# WOLF CREEK

WM 92-0035

Subject: Docket No. 50-482: Inservice Inspection Program  
Relief Requests

ISI RELIEF REQUEST IIR-23

Figure 5

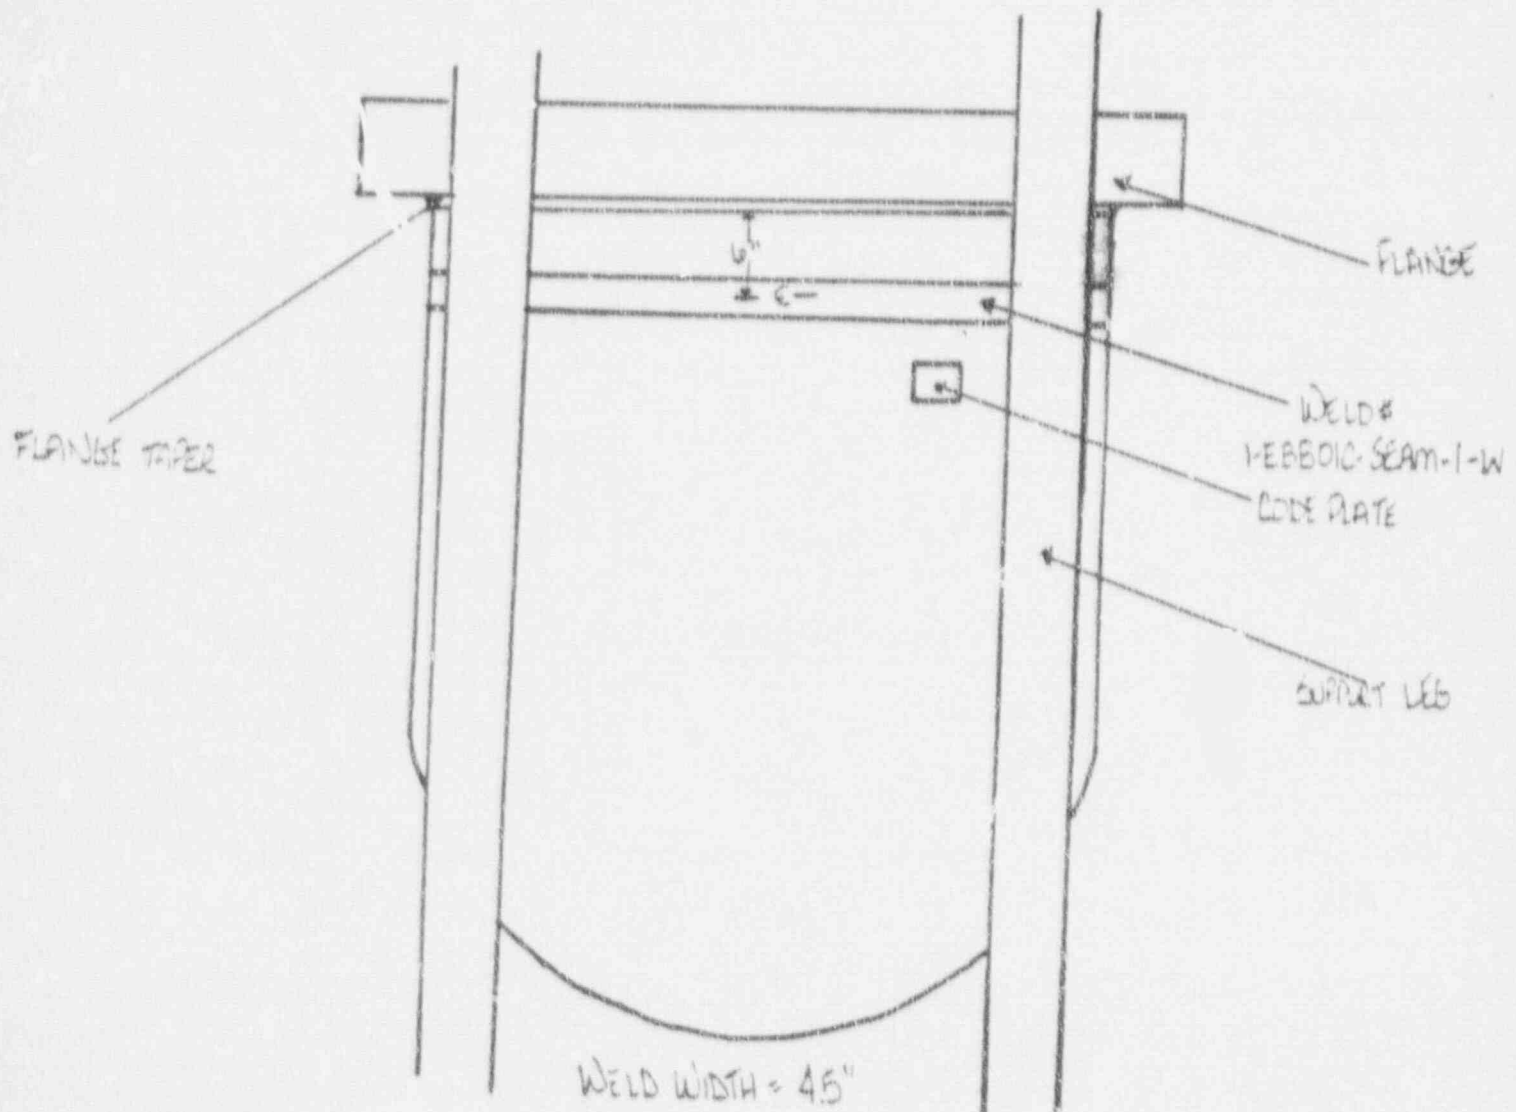
Basis for Relief: The volumetric examination of the subject weld is 22.4% obstructed by four (4) supports. The 60° axial scan on the tubesheet side is 30% obstructed by the support flange. The obstruction results from insufficient base metal between the weld and flange to complete this angle beam examination. There is approximately 1% obstruction due to weld taper and the code data plate. Reference Figure 5 for weld layout.

Alternate Examination: None; the Code required volumetric examination will be completed to the maximum extent practical.

Figure 6

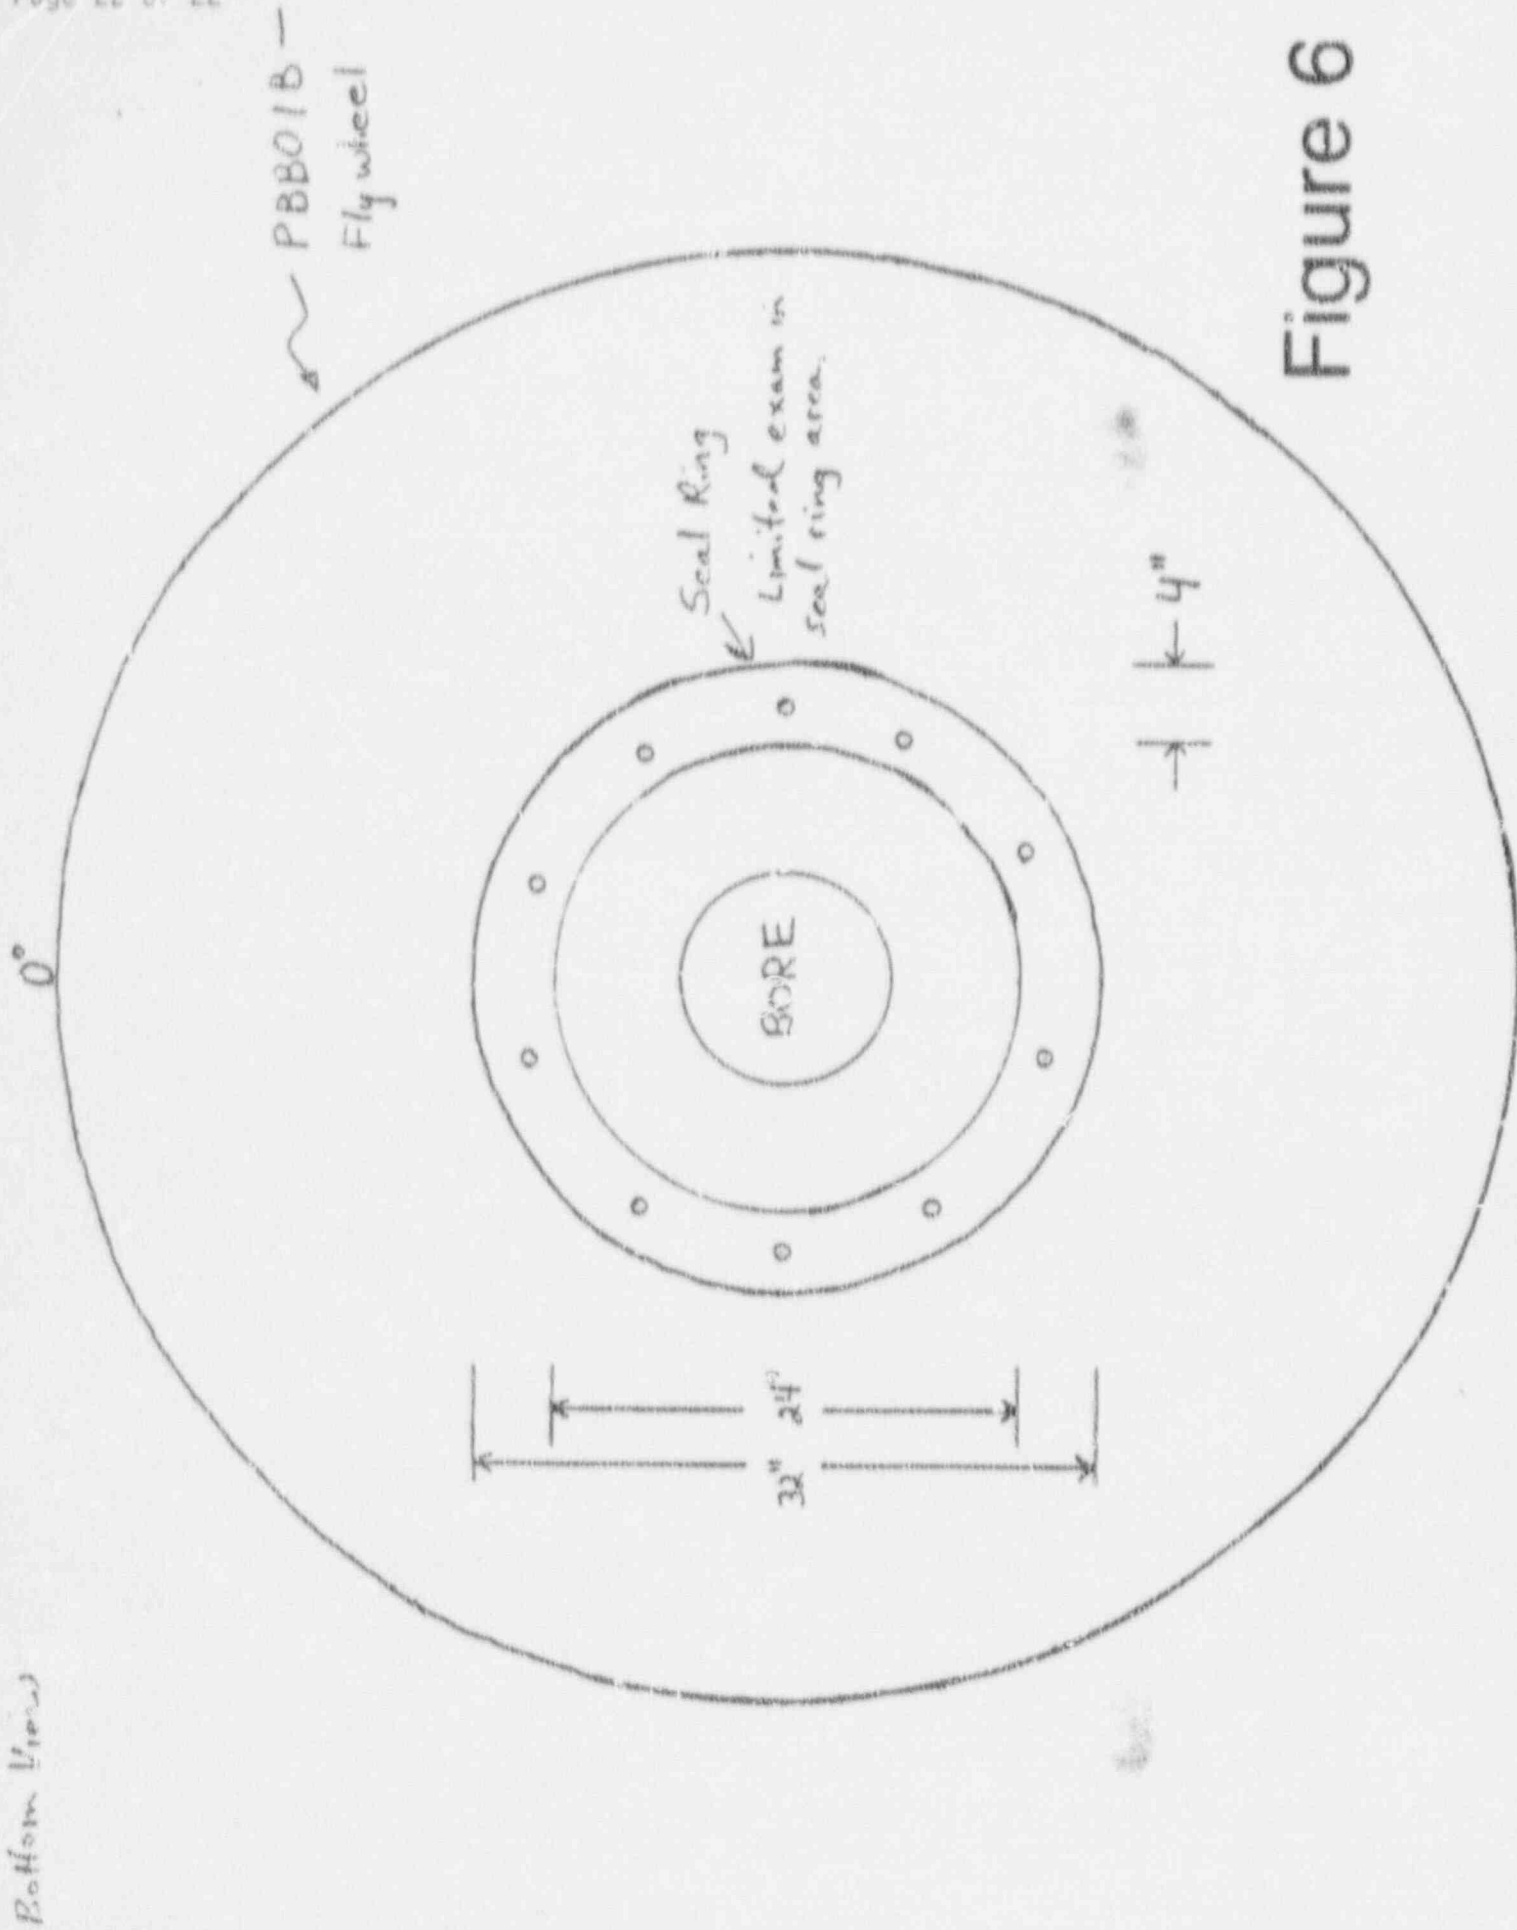
Basis for Relief: The surface examination of the subject Flywheel is 3% obstructed by a seal ring that is located on the bottom side of the Flywheel (reference Figure 6).

Tight clearances are required for seal ring location. This ring reduces the vacuum effect produced by the rotating flywheel in order to prevent oil from being sucked out of the oil reservoir stand pipe. After the ring is set, it should not be moved unless absolutely necessary.

Alternate Examination: None; the Code required surface examination will be completed to the maximum extent practical.
